Product End-of-Life (EOL) Notification		
AFFECTED PART NUMBER(S): LLNS-1T06-x LLNF-1T06-x LLFL-1T06-x		EOL No. 22
PART DESCRIPTION: LZ4 Narrow Spot TIR Lens LZ4 Narrow Flood TIR Lens LZ4 Flood TIR Lens		DATE: 7/6/2015
RECOMMENDED REPLACEMENT PART NUMBER(S):		
<i>Affected P/Ns</i>	<i>Replacement P/Ns</i>	<i>Description of Replacement Part</i>
LLNS-1T06-x	LLNS-2T06-x	<i>Form, fit and function compatible with the affected P/Ns, but note that:</i> 1. Inner light pipe diameter increased from 6.9mm (in affected P/Ns) to 7.9mm (in replacement P/Ns). See next page for details. 2. Performance comparison table is on next page.
LLNF-1T06-x	LLNF-2T06-x	
LLFL-1T06-x	LLFL-2T06-x	
REASON FOR EOL: Transitioning to set of lenses with larger inner light pipe diameter to ease pick and place in large scale fixture assembly.		
LAST ORDER DATE: LED Engin will continue to accept order for the affected parts until inventory is depleted		LAST SHIPMENT DATE: N/A

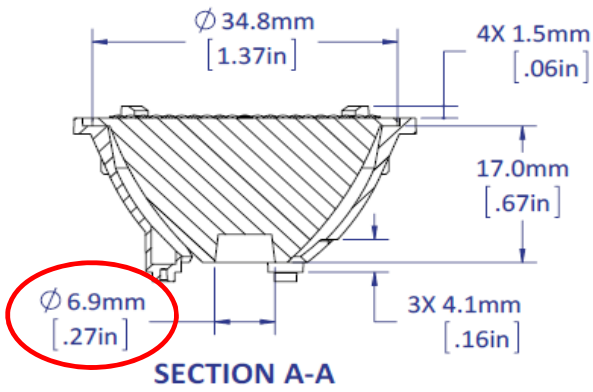
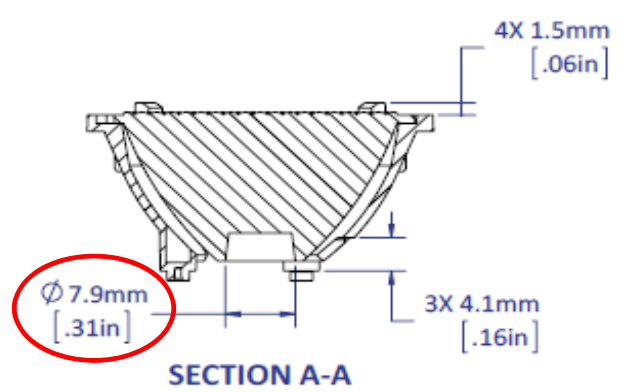
LLxx-1T06-x (Affected P/Ns)

LLxx-2T06-x (Replacement P/Ns)

Part Number	Beam Angle (deg)	On-axis Intensity (cd/lm)
LLNS-1T06-x	14	7.9
LLNS-2T06-x	14	8.8
LLNF-1T06-x	22	3.0
LLNF-2T06-x	25	2.9
LLFL-1T06-x	40	1.6
LLFL-2T06-x	37	1.6
